Palo Verde Nuclear Generating Station
5801 S. Wintersburg Road
Tonopah, AZ 85354-7529

102-07328-JF/WDP
September 1, 2016

**Subject: Palo Verde Nuclear Generating Station (PVNGS)
Units 1, 2, and 3 and Independent Spent Fuel Storage
Installation
Docket Nos. 50-528, 50-529, 50-530 and 72-44
License Nos. NPF-41, NPF-51 and NPF-74
PVNGS Emergency Plan, Revision 57**

PVNGS Emergency Plan, Revision 57

FIGURE 1 – ONSHIFT EMERGENCY ORGANIZATION

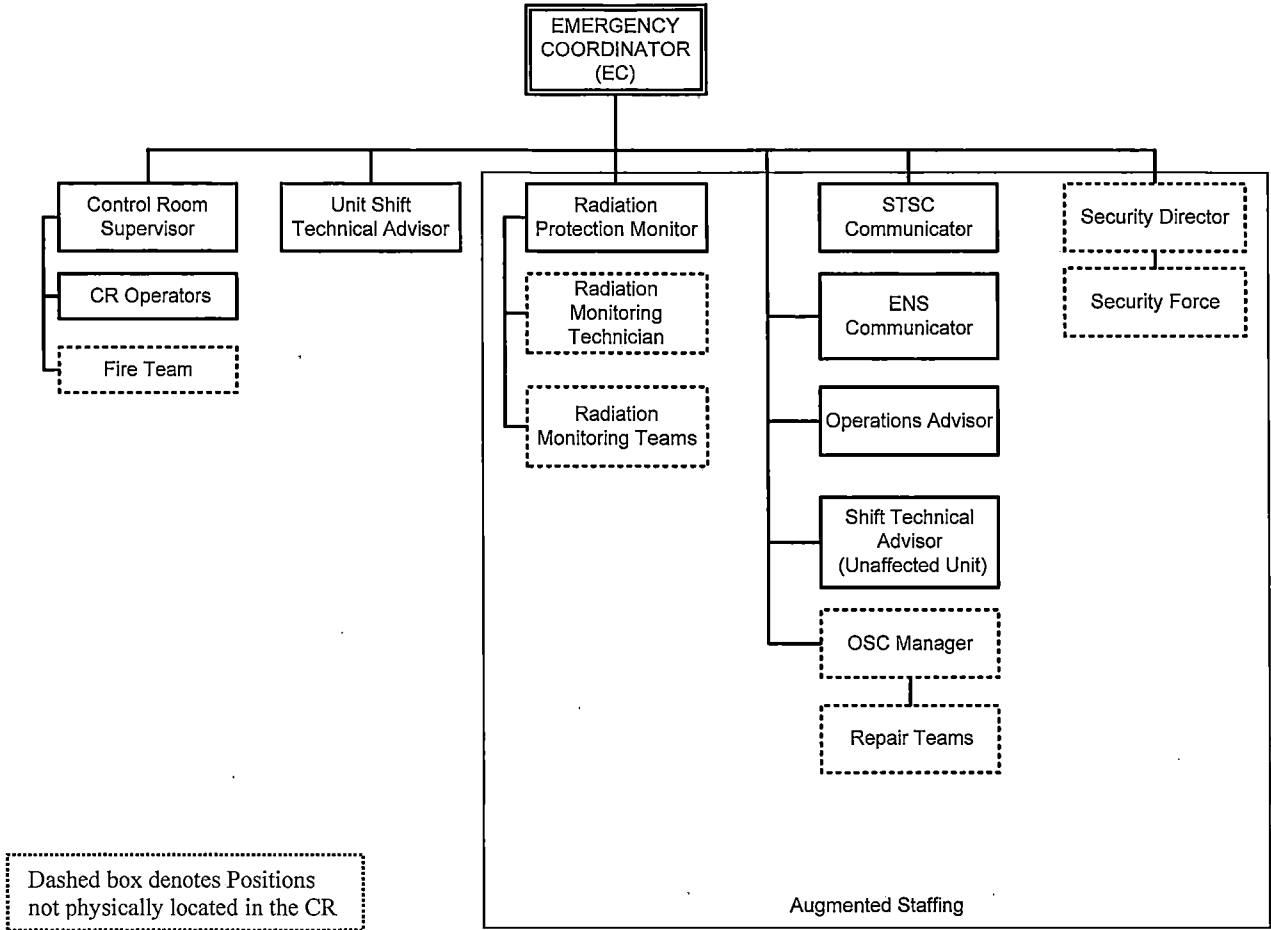
Figure 1 - added dashed box definition (AI #15-07536-002)

FIGURE 12 - DEMOGRAPHY WITHIN THE PLUME EXPOSURE PATHWAY EMERGENCY PLANNING ZONE

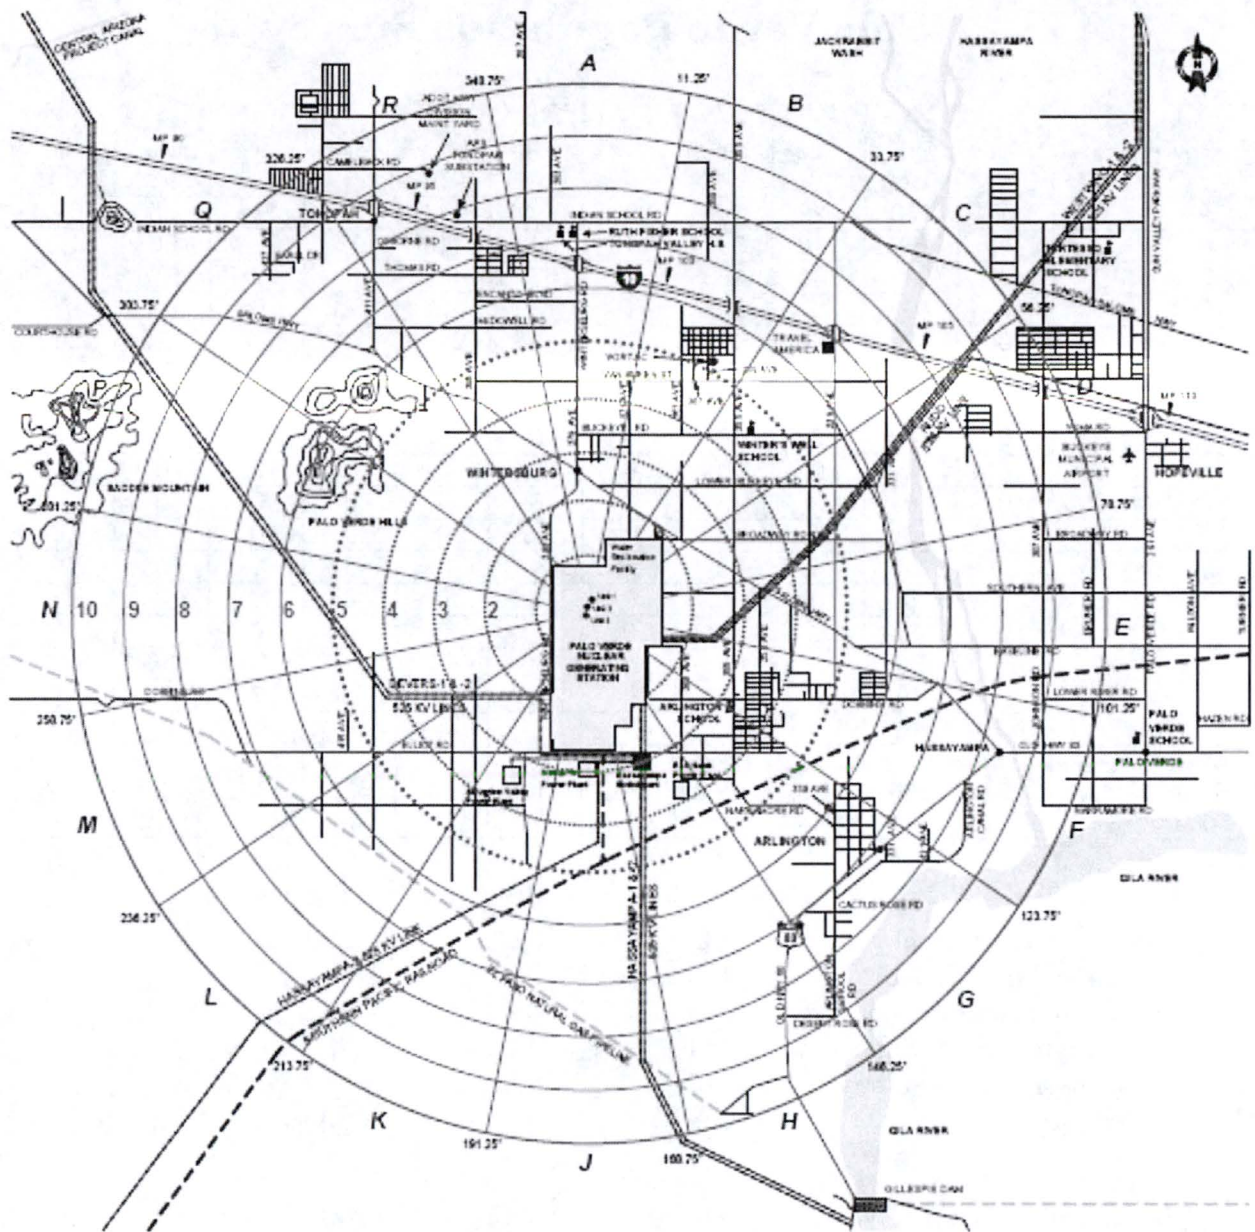
Figure 12 DEMOGRAPHY WITHIN THE PLUME EXPOSURE PATHWAY EMERGENCY PLANNING ZONE

Updated population statistics to latest provided by county emergency management. Added Crossroads charter High School to the list of schools located in the 10-mile EPZ.

- Revised Section 6.7.2 to "State and local government population data is used if available". 10CFR50 Appendix E requires that State and local data be used for the updates to the Evacuation Time Estimate but the previous revisions said 'may be used if available' indicating it was an option. PVNGS has used state and local data for their estimates. Additionally, the population data shown in Figure 12 is the latest provided by Maricopa County Emergency Management.

FIGURE 16 - PROMPT NOTIFICATION SYSTEM SIREN LOCATIONS

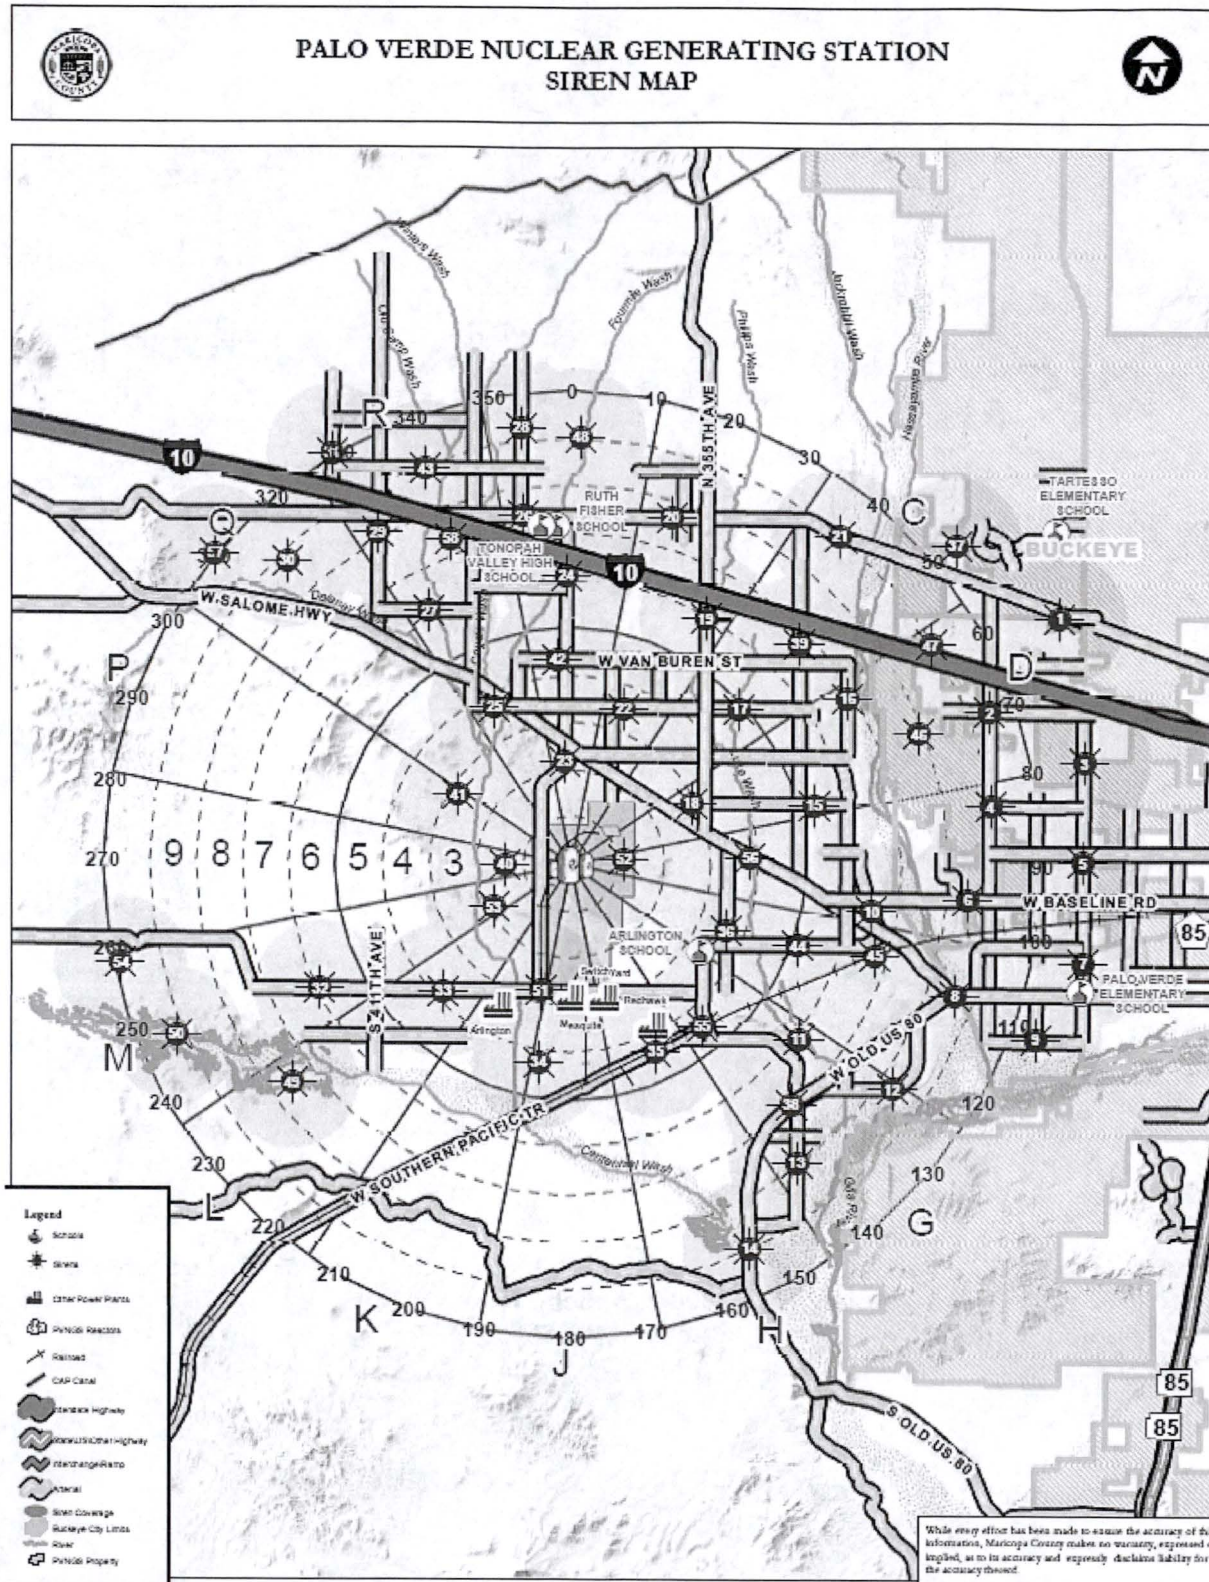
Figure 16 – added revised siren map (AI #14-02261-004)

- Figure 16 was updated to show the latest Federal Emergency Management Agency (FEMA)-approved Prompt Notification System Design siren map.
